APPLICATION FOR A RESIDENTIAL SITE IMPROVEMENT PERMIT/ CONSTRUCTION AUTHORIZATION FOR AN ON-SITE WASTEWATER SYSTEM, NEW WELL INSTALLATION, OR REPAIR OF EXISTING WELL

Re: Application for improvement permit for: 3 Bedroom House
Property Location: 10520 Harwood Ln, Charlotte, NC 28214 (PID 031-201-06)
Health Department File Number: **10839B (App ID 11895)**

SOIL/SITE EVALUATION for ON-SITE WASTEWATER SYSTEM

PROPOSED PLOT PLAN

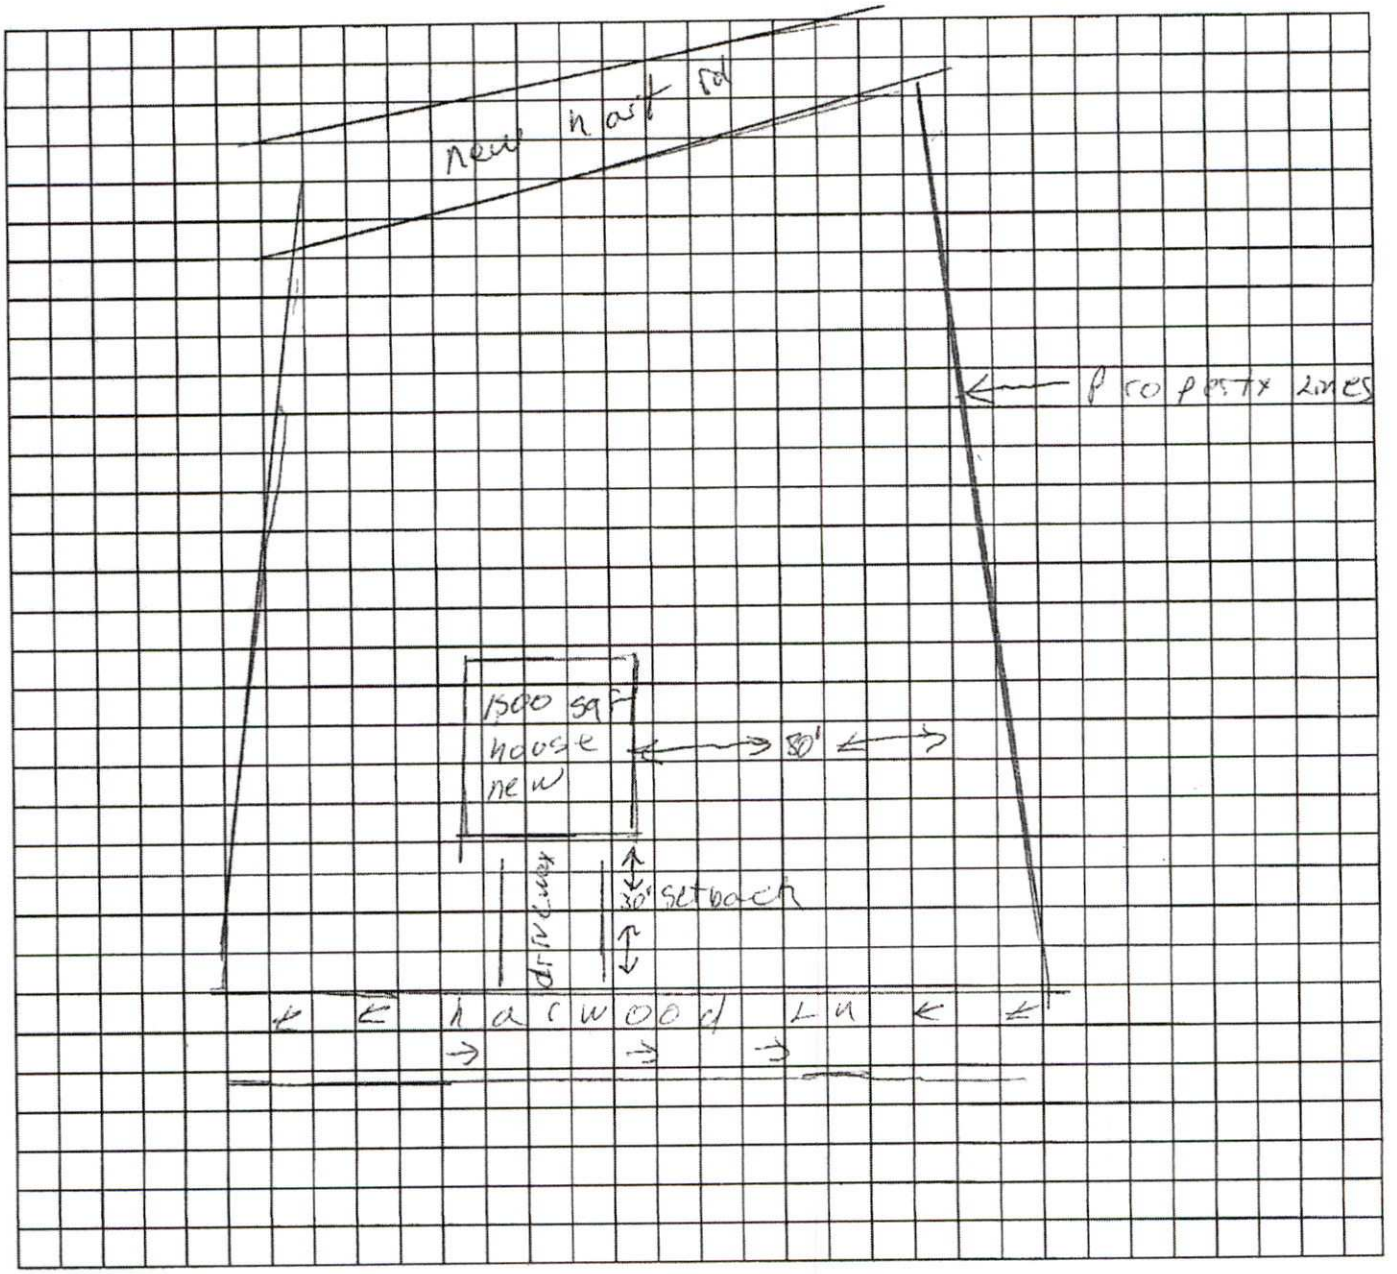
Based on the criteria set out in Title 15A, Subchapter 18A, of the North Carolina Administrative Code, Rules .1940 through .1948, the evaluation indicated that the site is **UNSUITABLE** for a ground absorption sewage system. Therefore, your request for an improvement permit is **DENIED.** A copy of the site evaluation is enclosed. The site is unsuitable based on the following:

- ☒ Unsuitable soil topography and/or landscape position (Rule .1940)
- ☒ Unsuitable soil characteristics (structure or clay mineralogy) (Rule .1941)
- ☒ Unsuitable soil wetness condition (Rule .1942)
- ☒ Unsuitable soil depth (Rule .1943)
- ☐ Presence of restrictive horizon (Rule .1944)
- ☒ Insufficient space for septic system and repair area (Rule .1945)
- ☐ Unsuitable for meeting required setbacks (Rule .1950)
- ☐ Other (Rule .1946)

For the reasons set out above, the property is currently classified **UNSUITABLE,** and an improvement permit shall not be issued for this site in accordance with Rule .1948 (c).

However, the site classified as **UNSUITABLE** may be classified as **PROVISIONALLY SUITABLE** if written documentation is provided that meets the requirements of Rule .1948(d). A copy of this rule is enclosed. You may hire a consultant to assist you if you wish to try to develop a plan under which your site could be reclassified as **PROVISIONALLY SUITABLE.**

Sketch of Soil Evaluation Locations

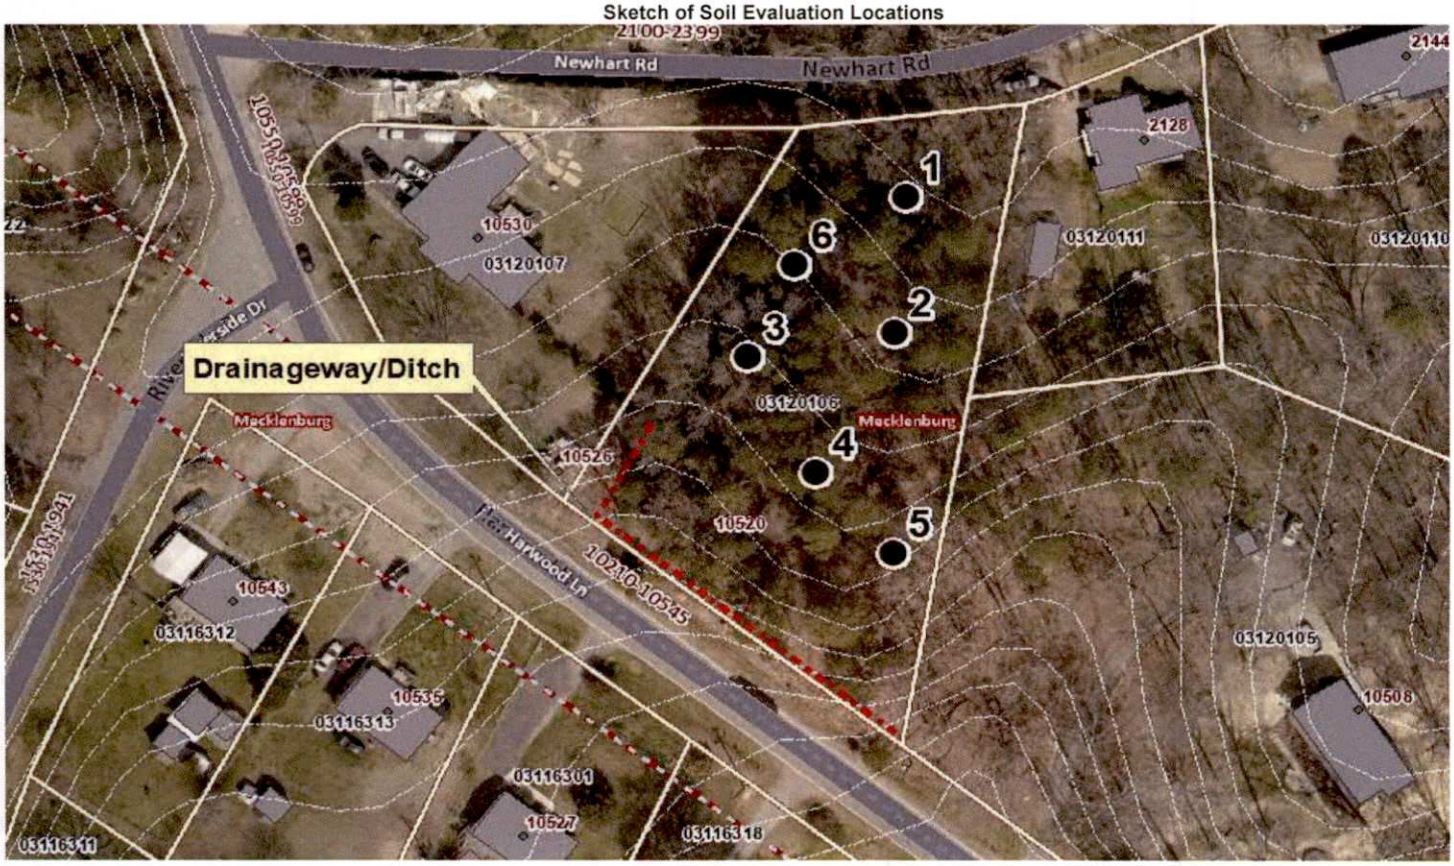
PROFILE #	.1940 Landscape Position/ Slope%	Horizon Depth (IN.)	SOIL MORPHOLOGY .1941 .1941 Structure/ Texture	.1941 Consistence Mineralogy	b PROFILE FACTORS .1942 Soil Wetness/ Color	.1943 Soil Depth (IN.)	.1956 Sapro Class	.1944 Restr Horiz	General Comments	Profile Class & LTAR	Maximum Trench Bottom Depth for 3' Wide Conventional Trench
Boring #1	R 4%	0 - 4	gr SCL	SS SP FR SEXP	10 YR 7/1 at 14"	12	NA	NA		US	NA
		4 - 12	sbk C	S P FI SEXP							
		12 - 24	sbk C	S VP VFI EXP							
Boring #2	NS 7%	0 - 3	gr SCL	SS SP FR SEXP	10YR 6/1 at 16"	18	NA	NA		US	NA
		3 - 18	sbk SC	S P FI SEXP							
		18 - 24	mass SCL	S SP FI SEXP							
Boring #3	HS 8%	0 - 12	gr SCL	SS SP FR SEXP	10YR 7/2 at 14"	24	NA	NA		US	NA
		12 - 24	sbk SC	S P FI SEXP							
Boring #4	NS 6%	0 - 3	gr SCL	SS SP FR SEXP	10YR 7/1 at 10"	12	NA	NA	grinding auger >18"	US	NA
		3 - 12	sbk C	S VP FI EXP							
		12 - 18	mass SCL	SS SP FI SEXP

Boring #5	NS 8%	0 - 6	gr SCL	SS SP FR SEXP	10YR 6/1 at 12"	12	NA	NA		US	NA
		6 - 12	sbk SCL	S SP FI SEXP							
		12 - 24	mass C	S VP VFI EXP							
Boring #6	HS 6%	0 - 6	gr SCL	SS SP FR SEXP	10 YR 8/1 at 12"	17	NA	NA		US	NA
		6 - 12	sbk SCL	SS SP FR SEXP							
		12 - 17	sbk SC	S P FI SEXP							
		17 - 26	mass C	S VP VFI EXP

COMMENTS:

Other Factors (.1946):
Soil Evaluation By: Jacob Presley, REHS, LSS
Others Present:
Site Classification (.1948): Unsuitable
Site Evaluation By: Jacob Presley, REHS, LSS
Others Present:
